ACCESSION NBR: 8108250280. DOC. DATE: 81/08/18 NOTARIZED: NO DOCKET #  
 FACIL: 50-244 Robert Emmet Ginna Nuclear Plant, Unit 1, Rochester G 05000244  
 AUTH. NAME: MAIER, J.E. AUTHOR AFFILIATION: Rochester Gas & Electric Corp.  
 RECIP. NAME: CRUTCHFIELD, D. RECIPIENT AFFILIATION: Operating Reactors Branch 5

SUBJECT: Forwards responses to Questions 1, 2, 3, 5 & 6 of SEP Topic  
 VI-7.8 re ESF switchover, per 810227 ltr.

Subject: SEP Topic VI-7.B, "ESF Switchover"  
R. E. Ginna Nuclear Power Plant  
Docket No. 50-244

Attachment: Additional Information Requested  
By February 27, 1981 Letter Regarding  
SEP Topic VI7.B, "ESF Switchover"

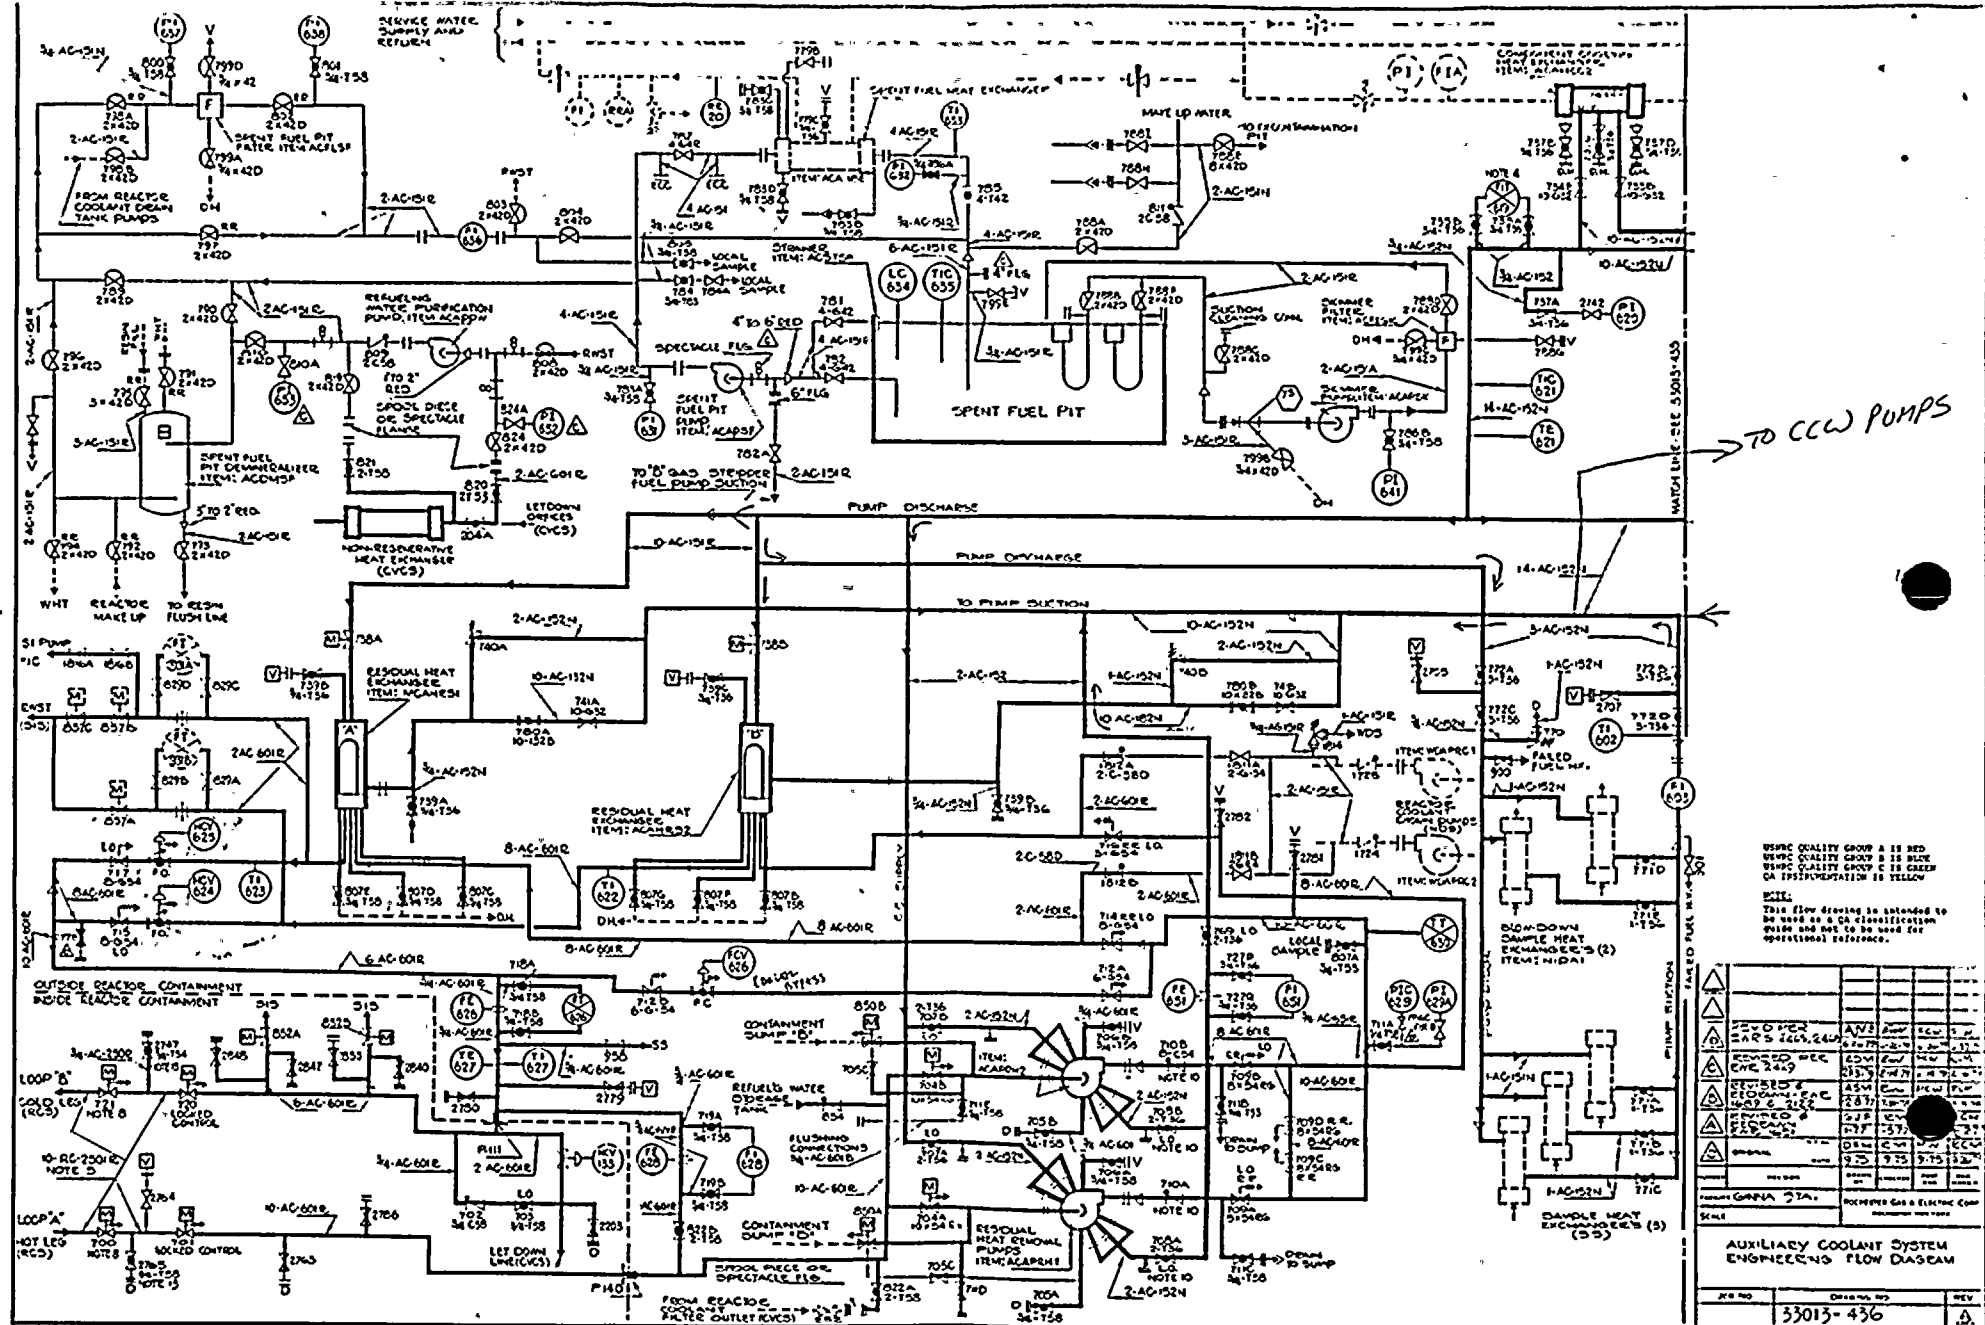
- (5) Describe the paths of the minimum flow lines from each ECCS pump discharge to the line end. This description should identify all valves in these lines, the signals that control each valve, the power sources for each valve, and the qualification of each valve.

- (6) For each minimum flow line that returns to a point other than the pump intake point, provide a single failure analysis and quantify the offsite dose rate, dose, and dose assumptions obtaining from all single failures that do not isolate these lines during the recirculation phase at ECC.

Response 5: The flow paths for these pumps are shown on RG&E drawings 33013-425, Safety Injection System, and 33013-436, Auxiliary Coolant System (attached).

The safety injection pumps each have a minimum flow line returning to the RWST. The three lines join upstream of two series air-operated valves, AOV 897 and AOV 898. These valves do not receive an actuation signal; however, they are interlocked with motor-operated valves 857A, B, and C such that the discharge of the RHR pumps cannot be connected with the suction of the SI pumps until AOV 897 and 898 are closed. The solenoid AOV 897 is powered from instrument bus 1B; AOV 898 from instrument bus 1D. These valves fail-closed on loss of power or air.

Response 6: As noted in response 5 above, only the SI pumps recirculate back to the RWST. Redundant air-operated valves, which fail-closed, are interlocked with the 857A, B and C valves in the line leading from the discharge of the RHR to the SI pumps. No single failure would thus prevent failure to close this minimum flow line.

# RWST Information

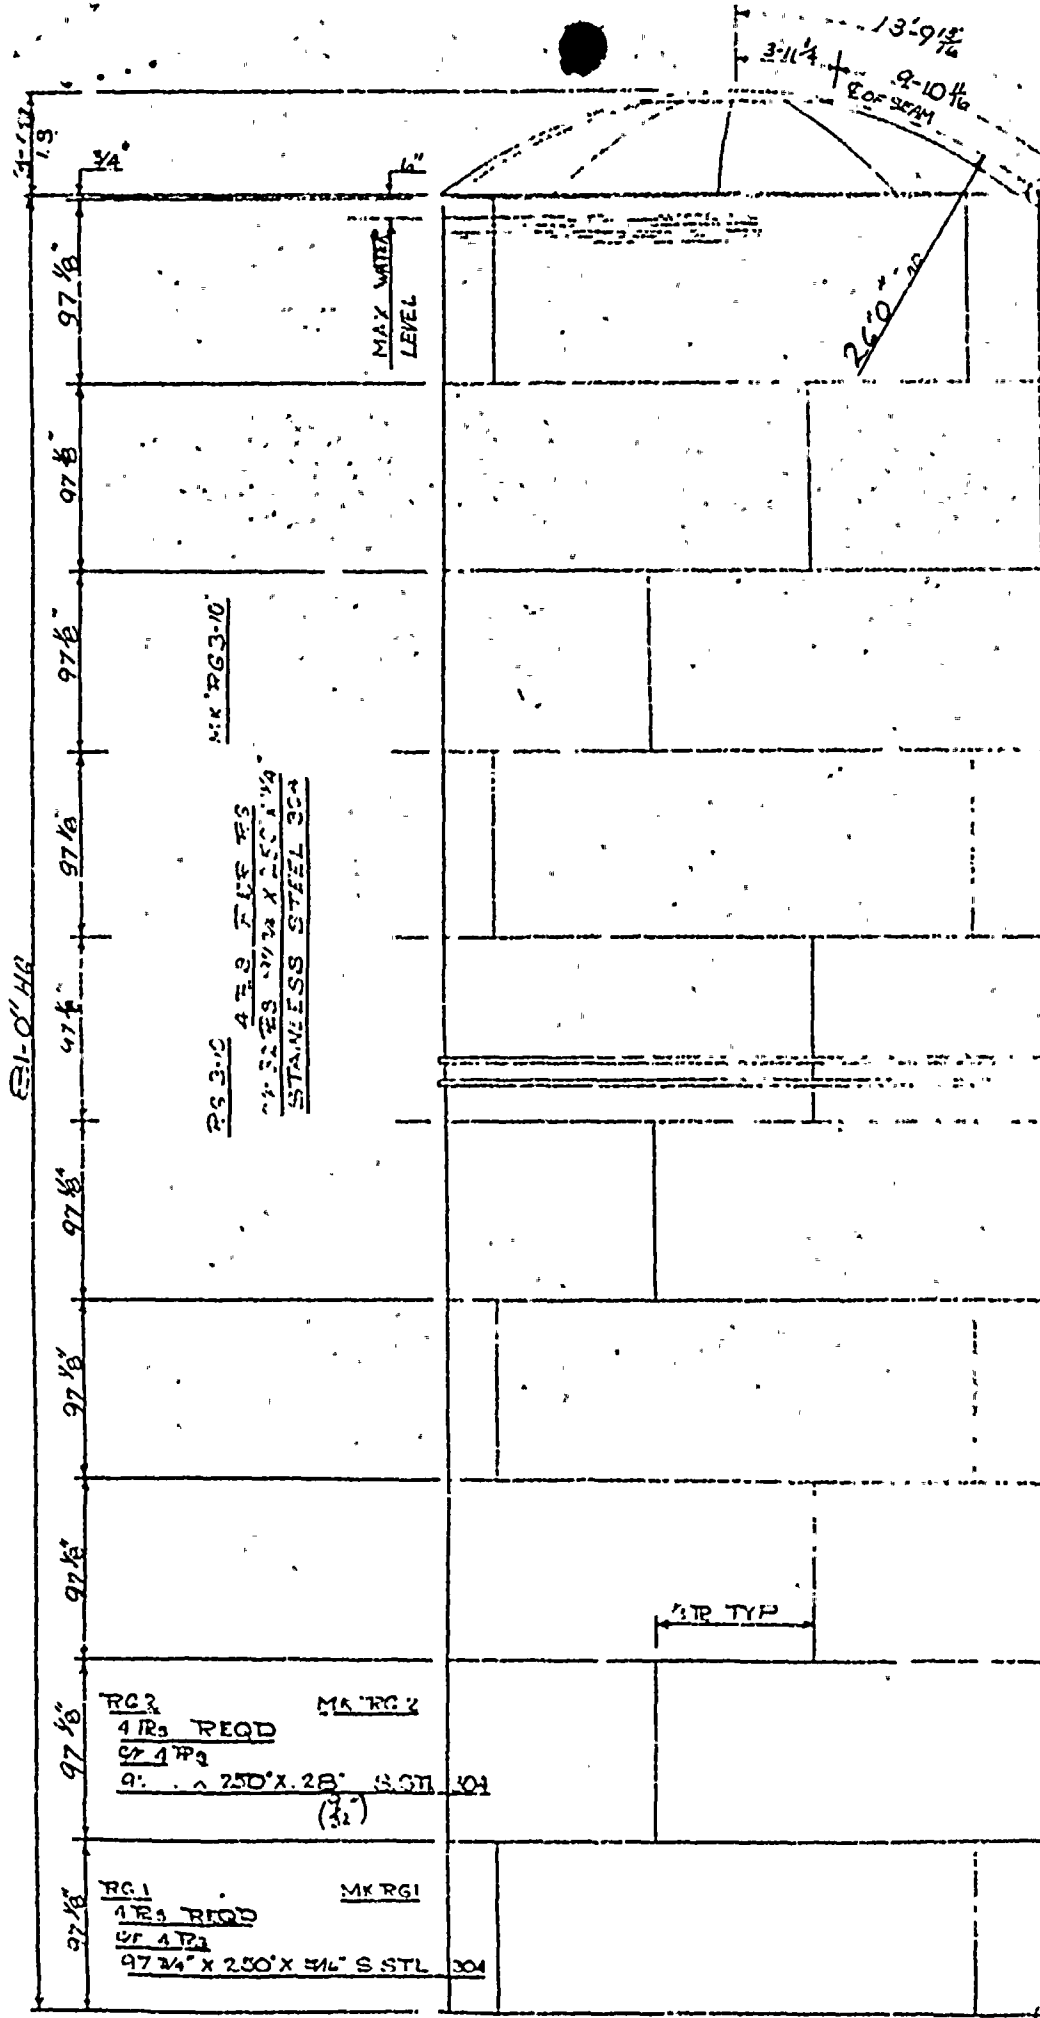
- (3) Describe the level sensing system that is used to indicate or detect the level in the tank that supplies injection coolant. This description should include sensor and data column location, freeze protection, freeze protection power supply and those items specified in (2) above.

Response 3: Level transmitter LT-920 and level indicating alarm LIA-921, whose sensors are located at the base of the RWST, provide the operator with redundant indication of RWST level. Since at Ginna the RWST is located in the auxiliary building, which is maintained above freezing temperatures, no freeze protection is provided.

Total Volume = 338,000 gal.  
 Normal = 300,000 gal.  
 Tech Spec Min = 230,000 gal.  
 Bottom of RWST: 236'2"  
 Pump Inlet Nozzle: 237'8"  
 10% Level: 244'6"  
 31% Level: 262'0"  
 Tank I.D. = 26.45'  
 Volume/Ft = 4,110 gal.  
 Volume to Pump Inlet Nozzle = 6,165 gal.  
 Volume to 10% Level = 34,250 gal.  
 Volume to 31% Level = 106,175 gal.
